Housing Board of Appeals Staff Report

Subject: BBA 14-0019

1614 South Blvd

Basement

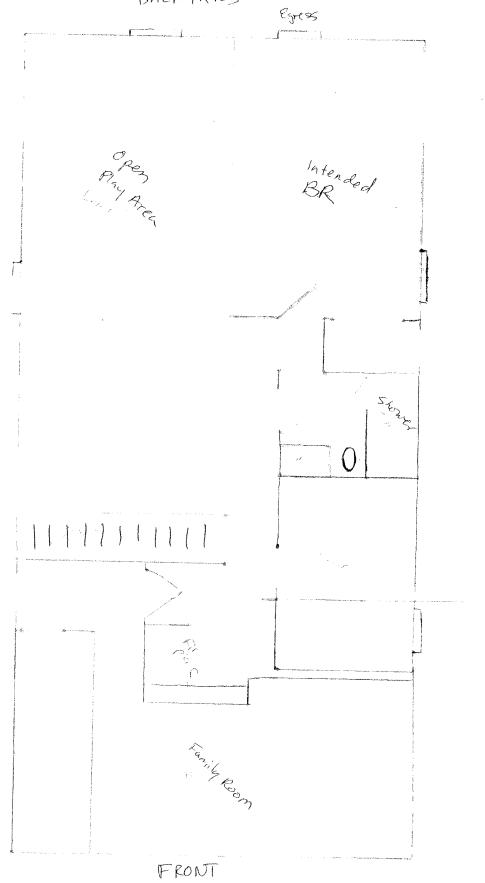
The owner of the residence located at 1614 South Blvd request a variance from the requirement for natural light and ventilation in the finished room in the cellar for use as a sleeping room. Natural light requires glazing area equal to 8% of the room's floor area and natural ventilation equal to 4% of that same area as required by section 8:502 (1) and (2).

There are 2 windows in the intended bedroom. The new egress window glazing area measures 39" high by 21-1/2" wide or 5.8 square feet. The second window, (existing) has a glazing area that measures 27" by 13-1/2" or 2.5 square feet. Total glazing area is 8.3 square feet.

The room measures 11' by 16'or 176 square feet. The code requires natural light to equal 8% of the total floor area in this case 14 square feet. This falls short by 5.7 square feet. The code also requires natural ventilation equal to 4% of the total floor area, in this case, 7 square feet. The ventilation area of the egress window measures 21-1/2 "by 17-1/2" or 2.6 square feet. The second windows ventilation area measures 30" by 16-1/2" or 3.4 square feet, (this window at the time of the inspection did not have a screen or the hardware to open the window but per the owner has since been repaired to open and has a screen) Total ventilation area measures 6 square feet. This falls short by 1 square foot.
